**Revised Phase B Site Investigation
Work Plan
Text, Tables, and Figures**

**Tronox LLC Facility
Henderson, Nevada**

Subject: Revised SAP Tables, Figures and Plates for the Phase B Source Area Investigation Work Plans for Areas I, II, III and IV, Tronox LLC Facility, Henderson, Nevada (Facility # H-000539)

Re: **Tronox LLC (TRX)**
NDEP Facility ID #H-000539
Nevada Division of Environmental Protection (NDEP) Response to:
Phase B Source Area Investigation Work Plan, Area I (Northern LOUs), Tronox LLC
Facility, Henderson, Nevada
Dated April 3, 2008

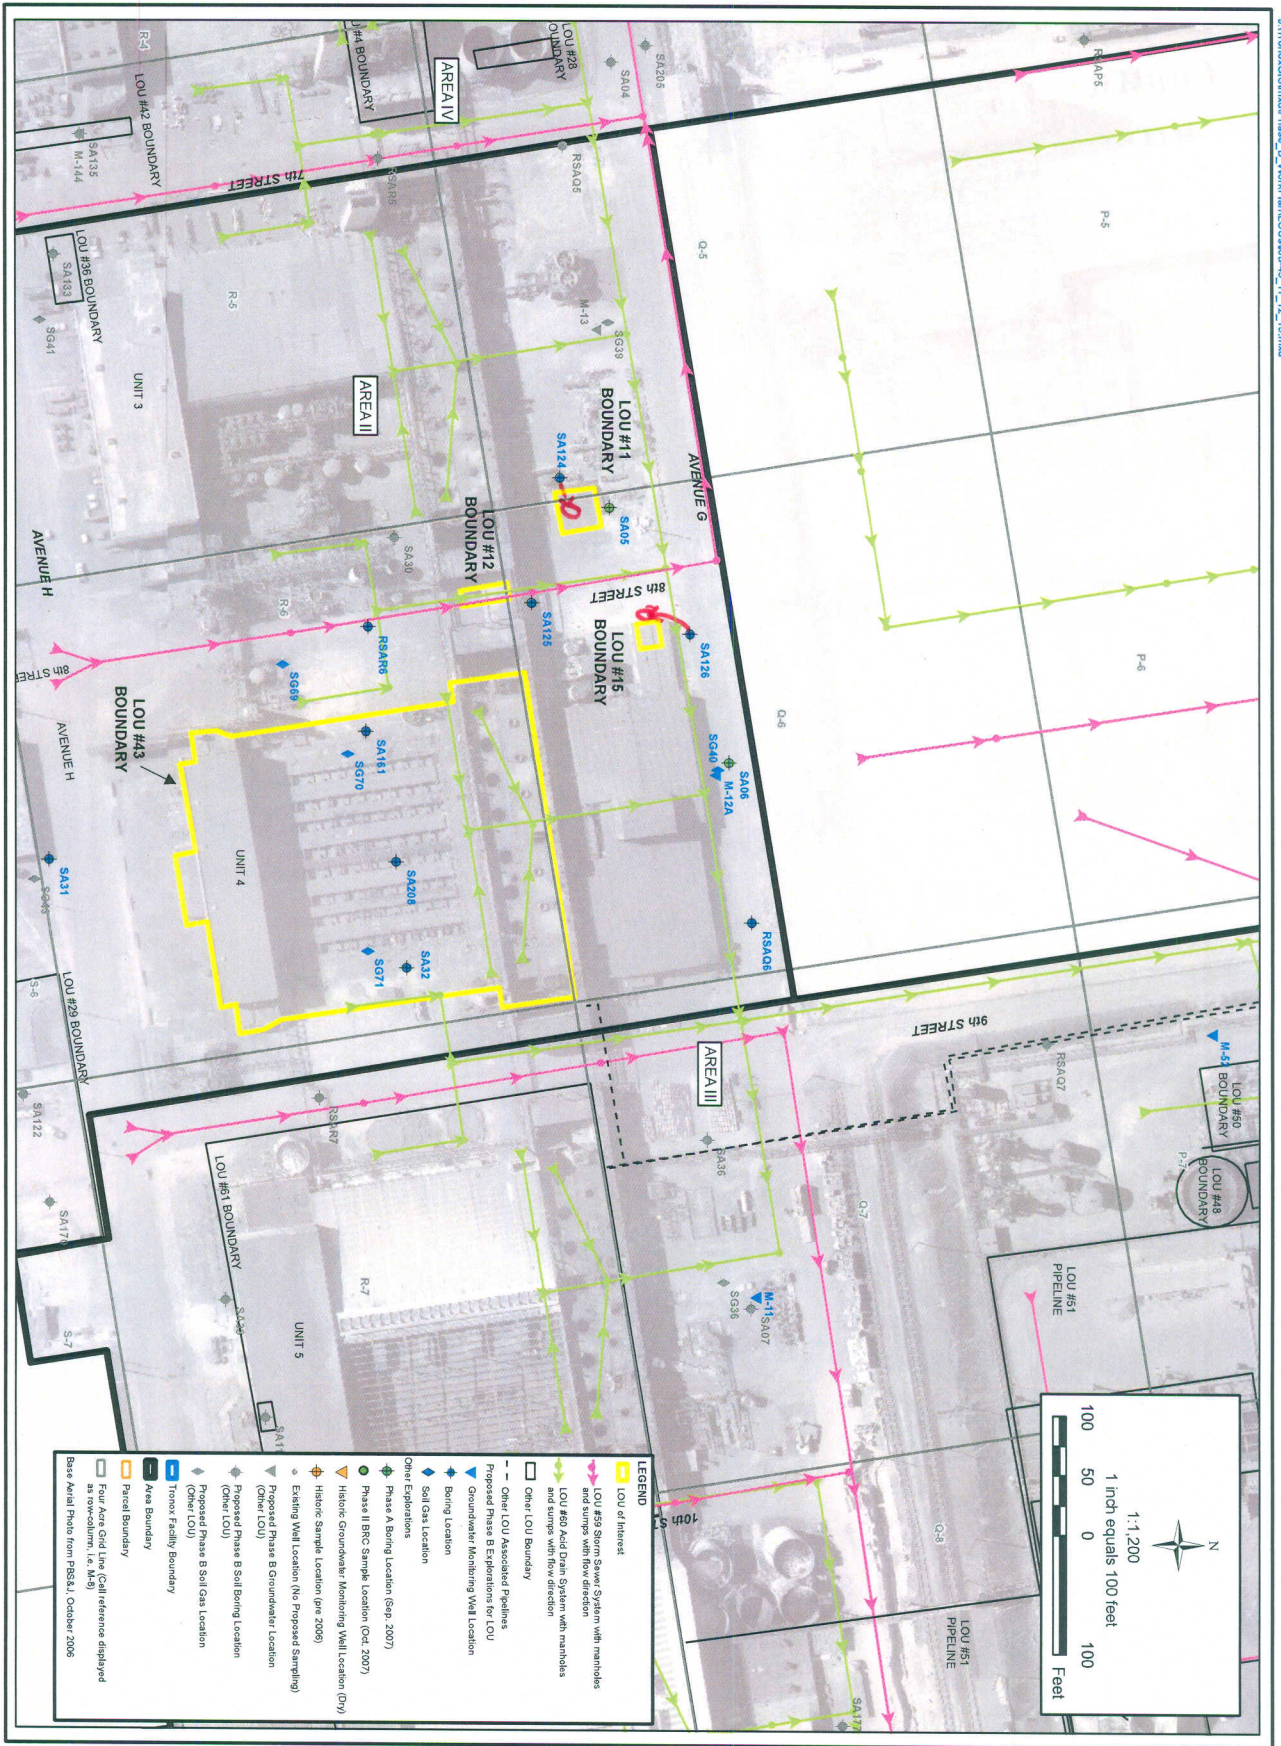
• move SA124 into LOU11
 • move SA126 adjacent to LOU15 to the west.

SHEET NUMBER	1
FIGURE NUMBER	X

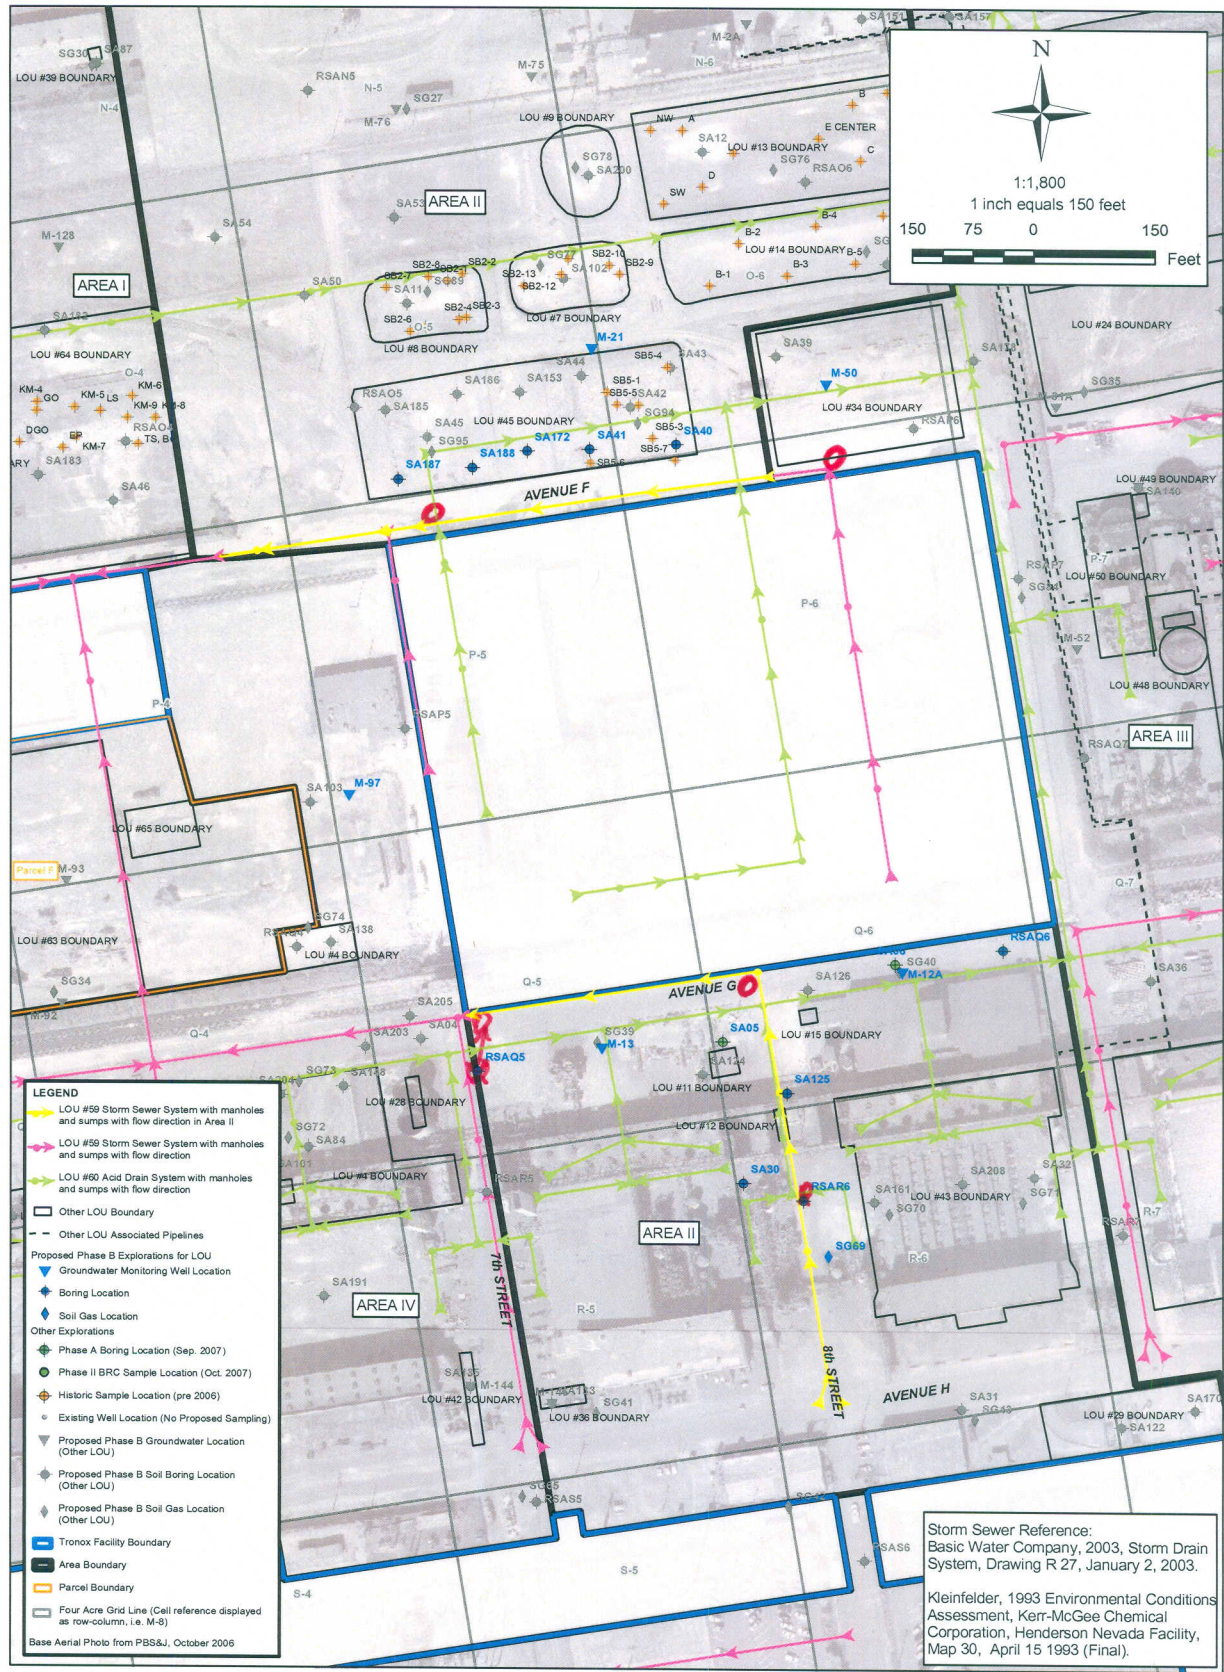
additional boring
 additional boring
 move RSAOS to south of Chemstar
 North of Chemstar, south of Lou 45, over Lou 60
 North of Chemstar, south of Lou 34, at 90° turn
 south of Chemstar, at 90° turn
 south of Chemstar, at 90° turn
 adjacent to Lou 59
 move RSA B6 overlaid

SHEET NUMBER:	X
FIGURE NUMBER:	1

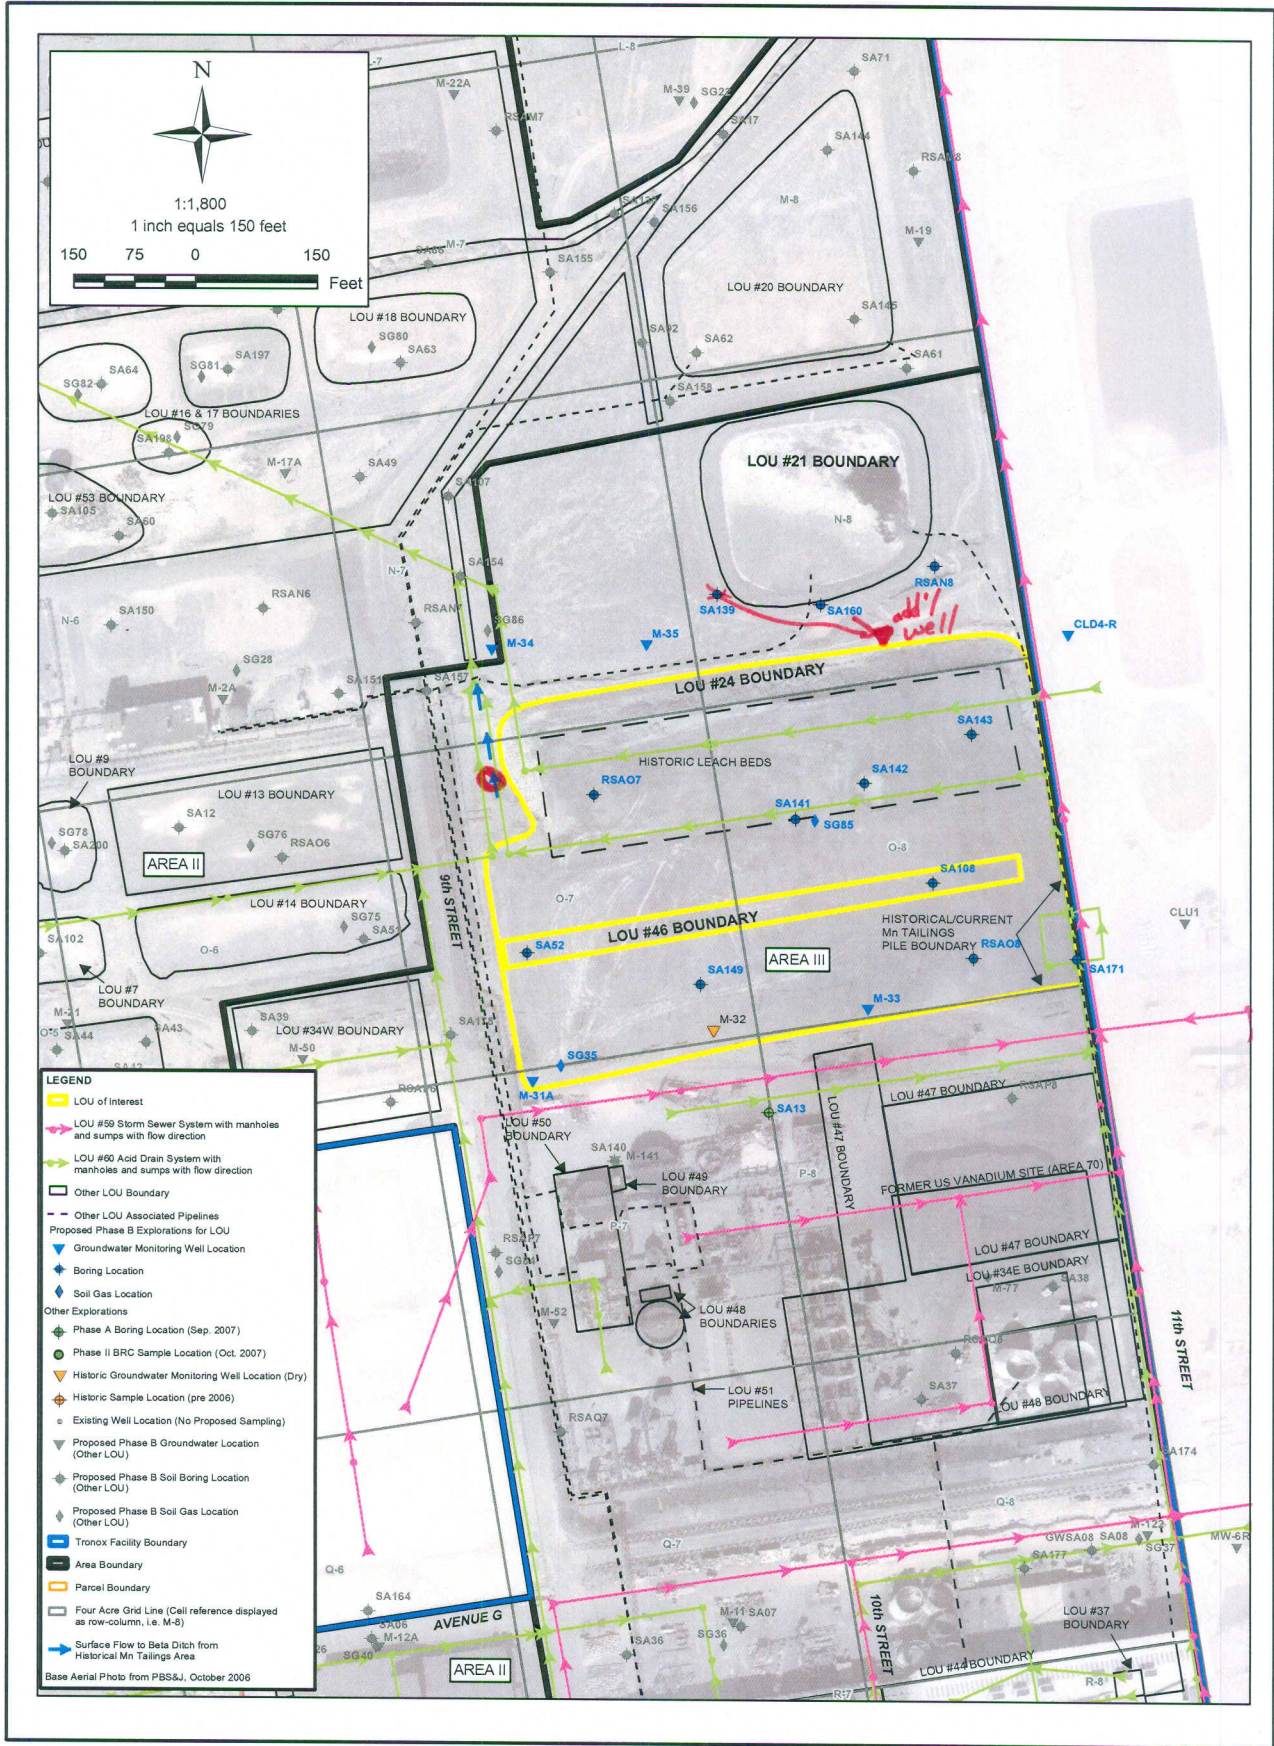
*additional boring located in surface flow from MN TAILINGS Area
 move SA139 to just north of LOU 24 & convert to monitoring well.*

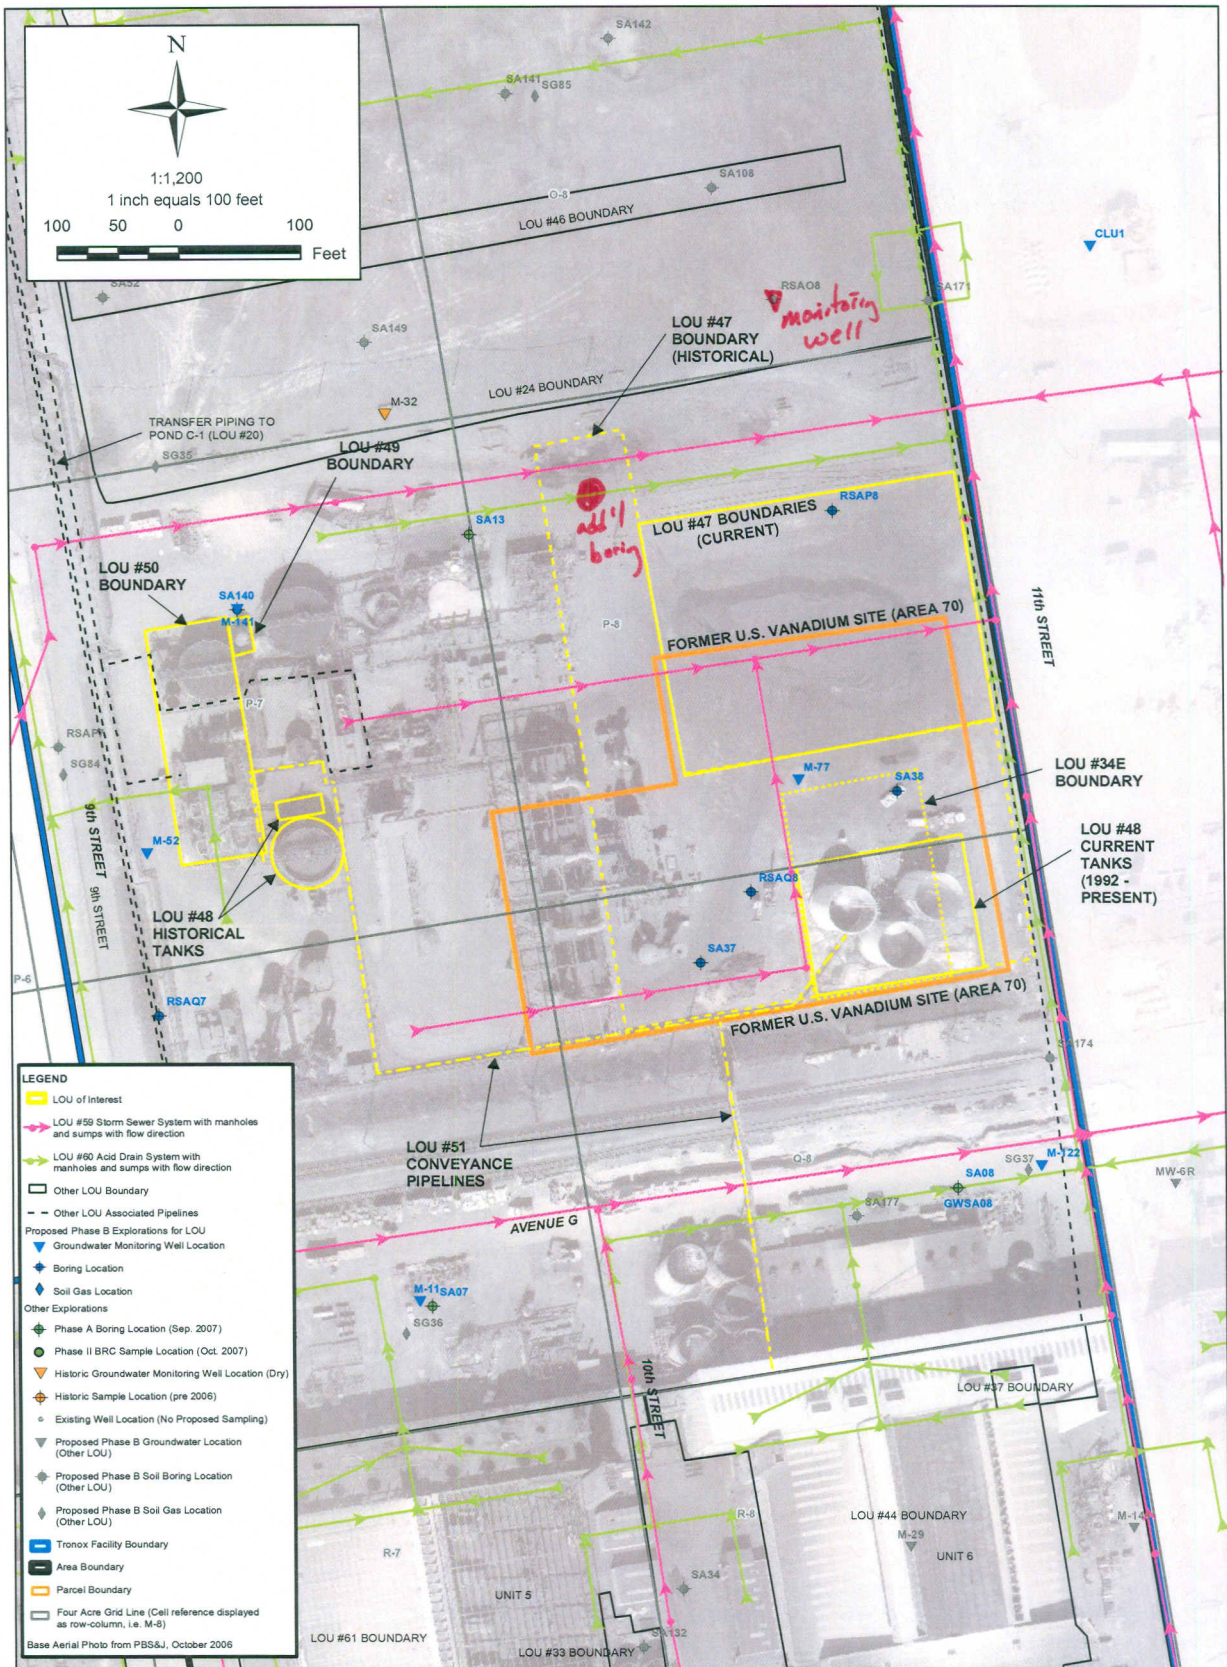
Additional boring on LOU 60 in northern portion of historical land.
convert RSA08 to monitoring well.

SHEET NUMBER:	X
FIGURE NUMBER:	1

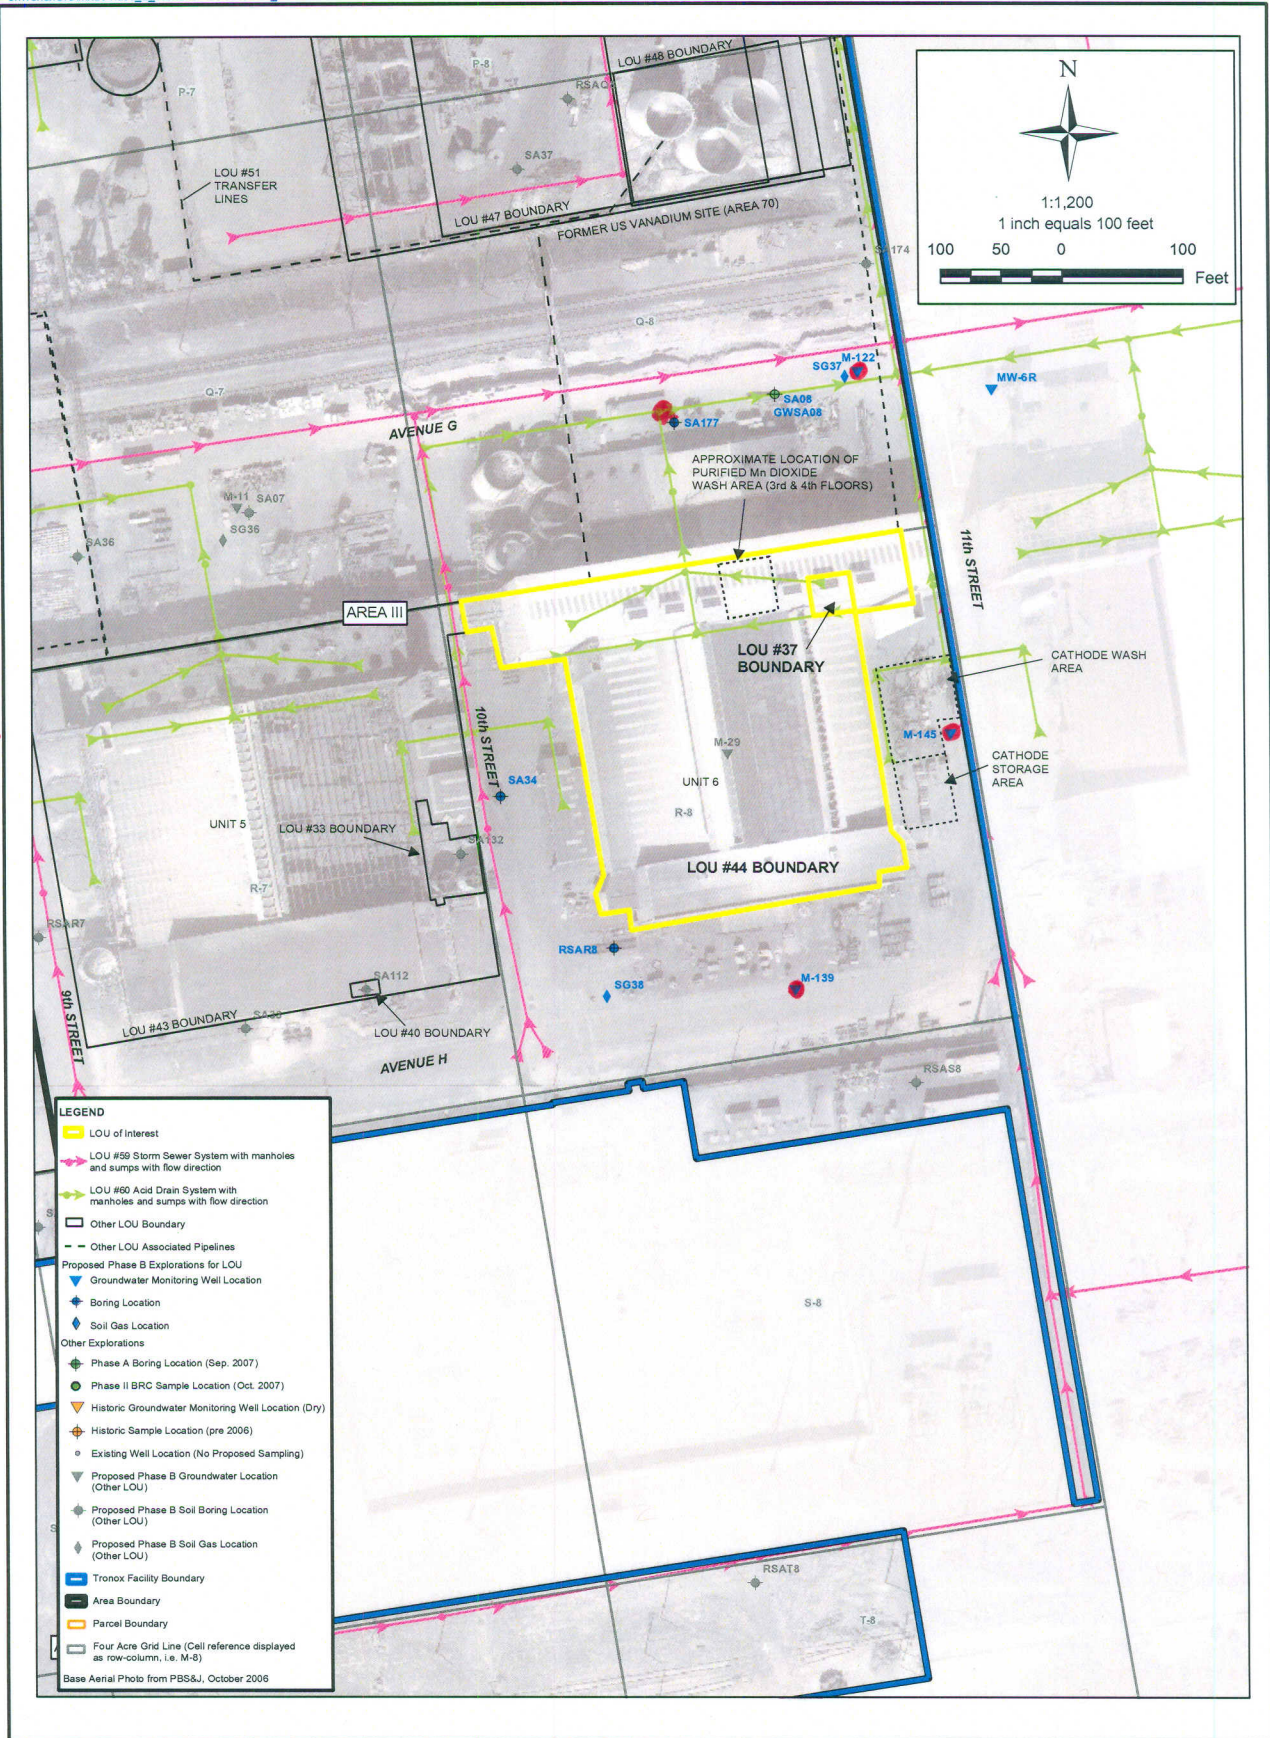
SA177 move to intersection/junction LOU 60.
Add borings collect samples for M-122, M-145 & M-139
